[Docket No. 96-CE-35-AD; Amendment 39-10213; AD 97-24-06]

Airworthiness Directives; Glasflugel Models Standard Libelle and Standard Libelle 201 B Sailplanes

ACTION: Final rule.

Appendix to AD 97-24-06

FIGURE 1

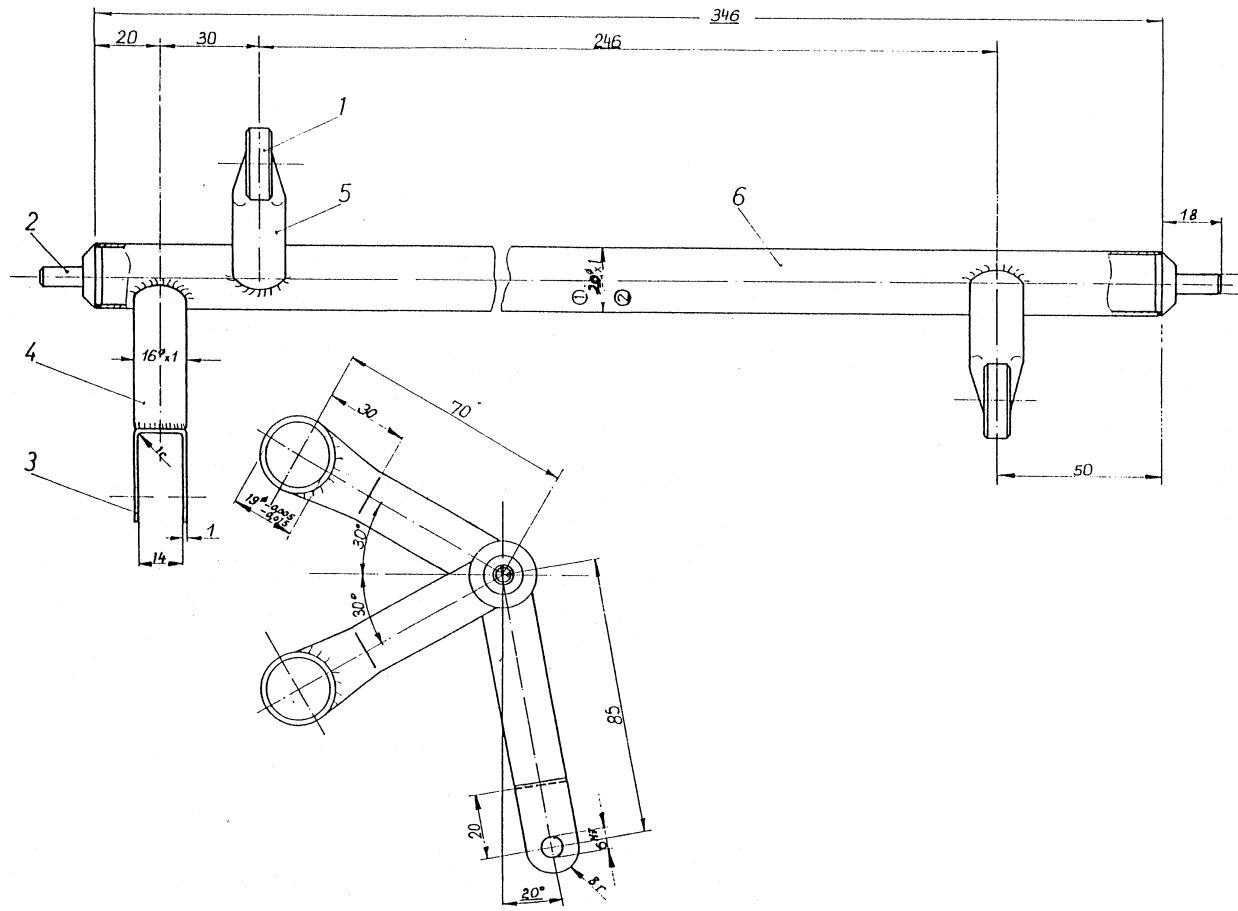
Using a magnifying glass (2x minimum) and a flashlight, inspect the aileron actuating shaft in the fuselage (see Figure 1) near the welding seams for cracks in the paint. If there is any cracked paint on the actuating shaft, prior to further flight, remove the actuating shaft and inspect for cracks in the shaft and welding seams using a dye-penetrant method. If there are no cracks or any other damage, flying operation can continue until the accumulation of 8 calendar months after the initial inspection required by this AD, at which time Method 2 or Method 3 shall be accomplished. If cracks are found, prior to further flight, accomplish Method 2 or Method 3.

As an alternative to Method 2, replace the original actuating shaft with a new reinforced shaft according to Figure 1.
